FILE P. I. No. 0004493, Fulton County **OFFICE** Preconstruction
CM-0004-00(493)
Marietta Boulevard Streetscape **DATE** March 21, 2007

SUBJECT: PROJECT CONCEPT REPORT

*Marietta Boulevard Streetscape from
Huff Road to Moores Mill Road Extension*

Project : CM-004-00(493) Marietta Boulevard Streetscape

TYPICAL SECTION
 MARIETTA BOULEVARD

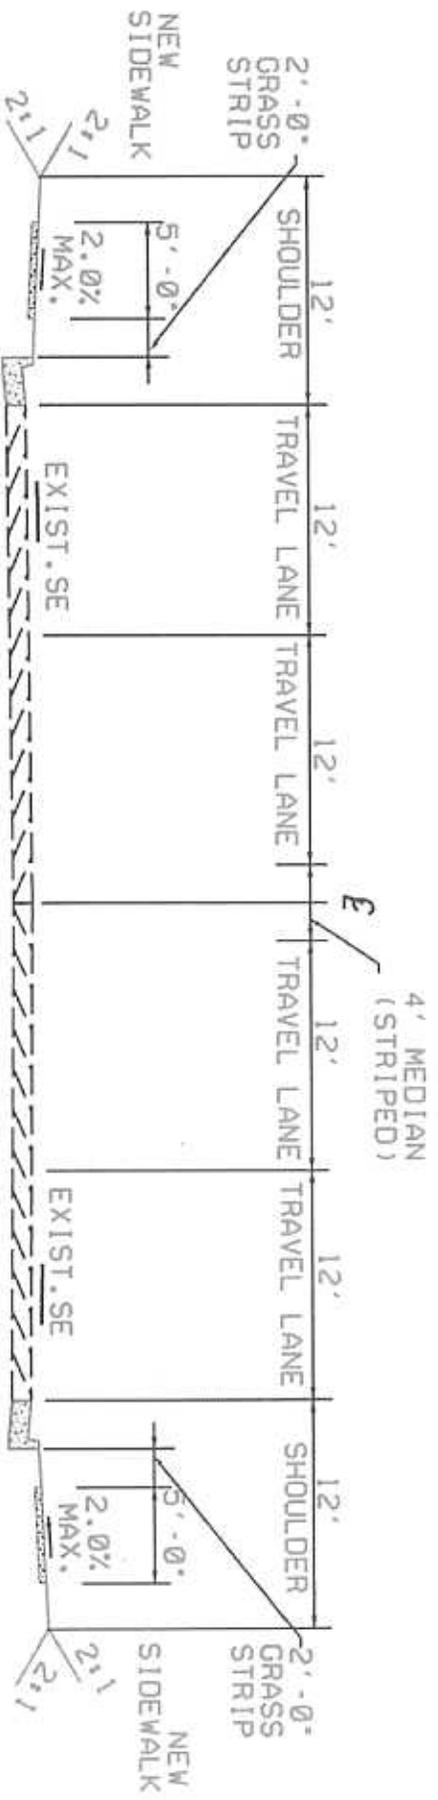
8. Note on the typical section that sidewalk is only to be constructed on one side of the roadway though it may be the right or left depending on the location along the Marietta Boulevard.

SIDEWALK TO BE LOCATED ALONG RIGHT SIDE OF ROADWAY (NORTH AND EAST)
 FROM HUFF ROAD TO CORONET AND LEFT SIDE OF ROADWAY (SOUTH AND WEST)
 FROM CORONET TO EXTENDED MOORES MILL ROAD
